UNITED STATES PATENT AND TRADEMARK OFFICE

| APPLICATION NO. | FILING DATE | FIRST NAMED INVENTOR | ATTORNEY DOCKET NO. | CONFIRMATION NO. |
|-----------------|-------------|----------------------|-----------------------|------------------|
| 09/942,528 | 08/29/2001 | Philipp Lang | 6750-0001 OP-001.00US | 6548 |

Office Action Summary

DETAILED ACTION

Figure 15 - U.S. Patent 6,248,063 to Barnhill et al.

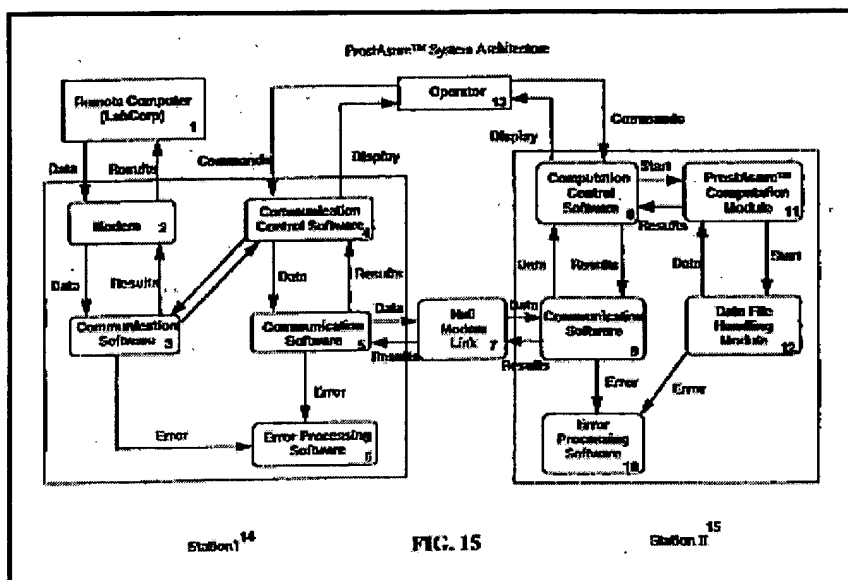
4. As per claims 1 and 48, Barnhill et al. disclose a method comprising the steps of providing data from a local computer; transmitting the data to a remote location and analyzing the data at the remote computer, thereby deriving quantitative information of the data (abstract, summary of the invention; i.e. Figs. 4, 15). Barnhill et al. do not explicitly disclose a method wherein the data is comprised of digitized x-ray images and the quantitative analysis is based on receipt of the x-ray images.

5. Barnhill et al. disclose a network system configured for receipt and analysis of patient data such as x-ray images (column 20, lines 3-28).

6. It would have been obvious to modify the method of Barnhill et al. such that it was configured to receive digitized x-ray images for quantitative analysis. One would have been motivated to make such a modification so that images could be compared with modeling image data to track the progress/ stage of a disease as taught by Barnhill et al. (column 20, lines 3-28). Additionally, it would have been obvious to a practitioner in the radiation art to utilize digital

Figure 1 - U.S. Patent 6,246,745 to Bi et al.

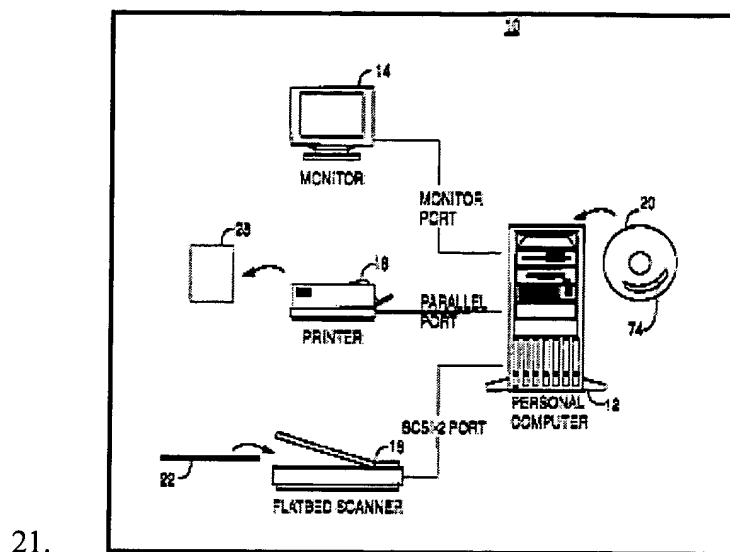
22. Bi et al. disclose a method wherein the x-ray image is an x-ray film (22) and wherein the film is digitized using a scanning unit (18).

23. It would have been obvious to modify the method of Barnhill et al. such that it incorporated an x-ray film and wherein the film is digitized using a scanning unit. One would have been motivated to make such a modification so that a film is converted to digital form for electronic transmission via a network and for retrieval and storage as taught by Bi et al. (abstract; Figs. 1 and 2).

Figure 2 - U.S. Patent 5,335,260 to Arnold

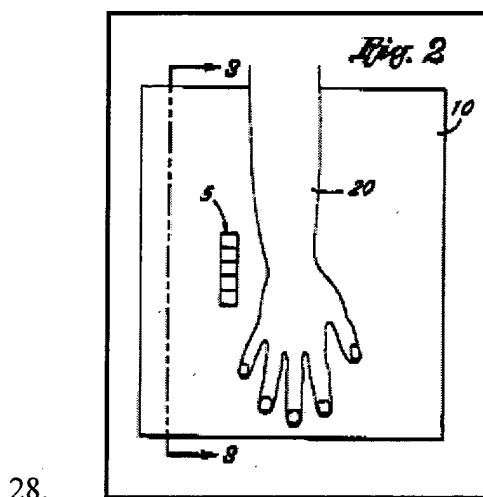
29. Arnold teaches a method wherein an x-ray image includes an external standard (5).

30. It would have been obvious to further modify the method of Barnhill et al. such that it incorporated an x-ray image including an external standard. One would have been motivated to make such a modification so that x-ray imagery could be quantified for calcium, bone mass and bone density by comparison of x-ray attenuation caused by an external standard to the attenuation caused by the object of interest as taught by Arnold (abstract; column 2, lines 48-54).

Figure 1 - U.S. Patent 5,917,877 to Chiabrera et al.

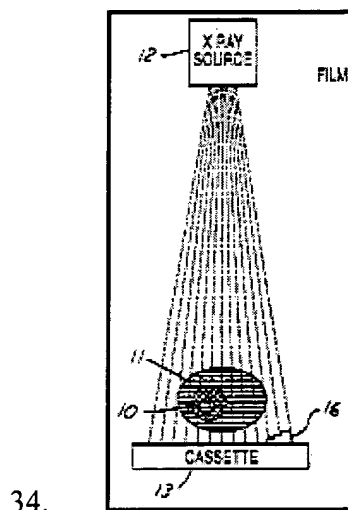
35. As per claims 32, 39 and 40, Chiabrera et al. disclose an apparatus comprising an x-ray film holder (13) and X-ray film ((23) - Fig. 2) and a calibration phantom (16). Chiabrera et al. do

not explicitly disclose a calibration phantom comprising a marker in an area of known density; the markers comprising a plurality of geometrical patterns.

36. It would have been obvious to modify the apparatus of Chiabrera et al. such that it incorporated a calibration phantom comprising a marker in an area of known density. One would have been motivated to make such a modification so that the marker serves as a positioning indicator for the phantom as well as an indicator for the attenuation attributes of the phantom at the indicated position. Additionally, it is the position of the examiner that the patterning of the markers would not deviate from the scope and spirit of the disclosed invention.

37. As per claim 33, Chiabrera et al. disclose an apparatus wherein the calibration phantom projects free of bone tissue (Fig. 1, above).

38. As per claim 34, Chiabrera et al. disclose an apparatus wherein the calibration phantom is attached to the x-ray film holder or a detector system (Fig. 1, above).

39. As per claim 35, 41, 42 and 43 Chiabrera et al. disclose an apparatus wherein the calibration phantom is integral to the x-ray film holder included between two physical layers of x-ray film and included within one of the physical layers of the x-ray film (Figs. 1-3).
